September 3, 2010

Ref: Sound Study
Shelborne Hotel
1801 Collins Avenue
Miami Beach, FL 33139

This letter will serve as my report on a Sound Study conducted at your office's request as required for an Application for Modification of Conditional Use Permit at the above referenced property. This report is based on data gathered during two site visits, subsequent analysis of this data, drawings and other information submitted by the applicant, photographs and aerial maps obtained using our Google Pro account.

DIA-1H

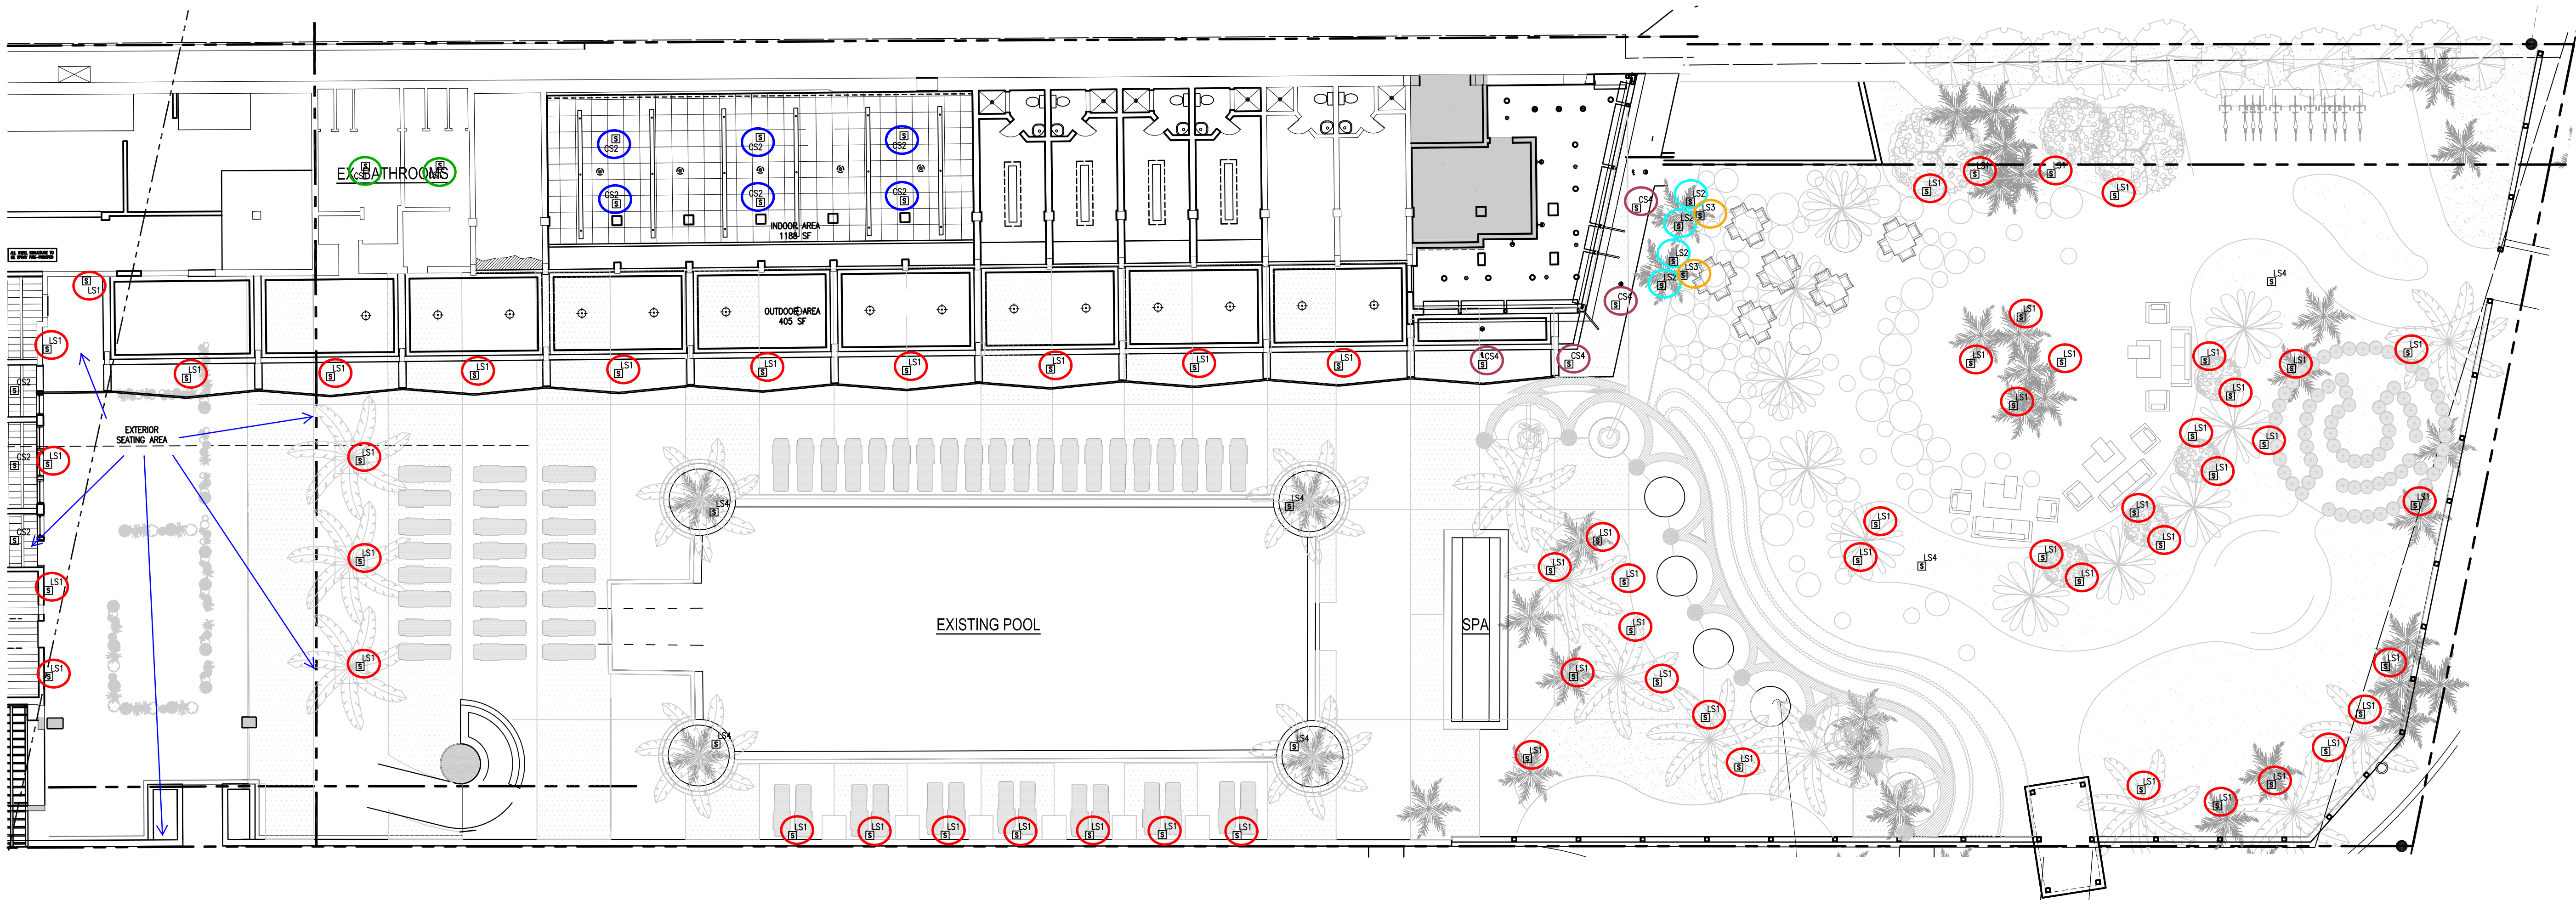
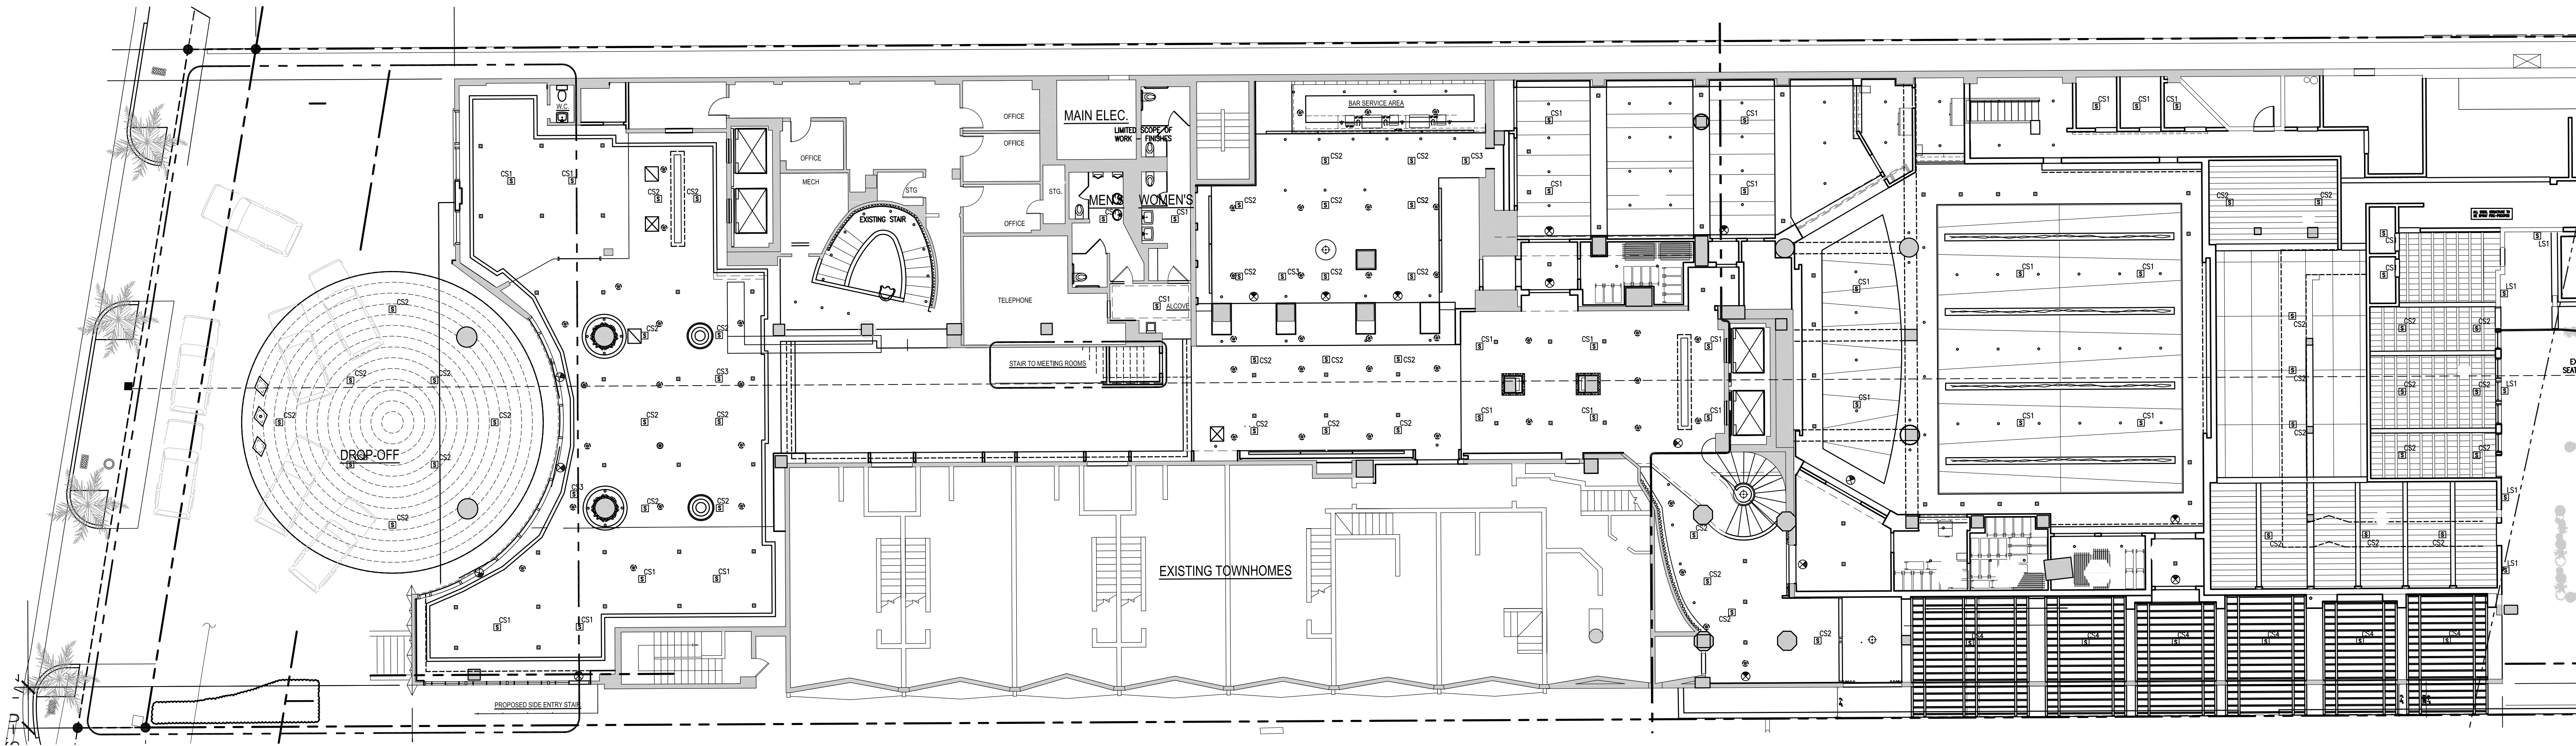
In reviewing the plans and drawings provided by the applicant, it is apparent the sound system design is consistent with the intent of the City's Noise Ordinance; amplified music should not be audible at adjacent properties. The system will consist of a large number of small speaker systems located throughout the Pool Deck and Garden areas in such a way as to ensure excellent uniformity of sound distribution. When properly adjusted, it shall be possible for music played at background levels to be clearly audible to the Shelborne's guests without intruding on neighboring properties.

Based on measurements of typical ambient noise levels (see measurement charts below) the system's nominal operating level should be adjusted to approximately 60 to 65 dBA between 8:00 a.m. and 11:00 p.m. The system's electronic management controller should be set to automatically decrease levels by 10 decibels between the hours of 11:00 p.m. and 2:00 a.m. Finally, the music system should be programmed to be muted during those periods when the two facilities are not operational, i.e., 2:00 a.m. to 6:00 a.m.

- E. New speakers shall be installed as shown in the attached plans. The speakers shall be as specified by the sound system integrator and shall be mounted in the locations indicated on page 12 of this document.
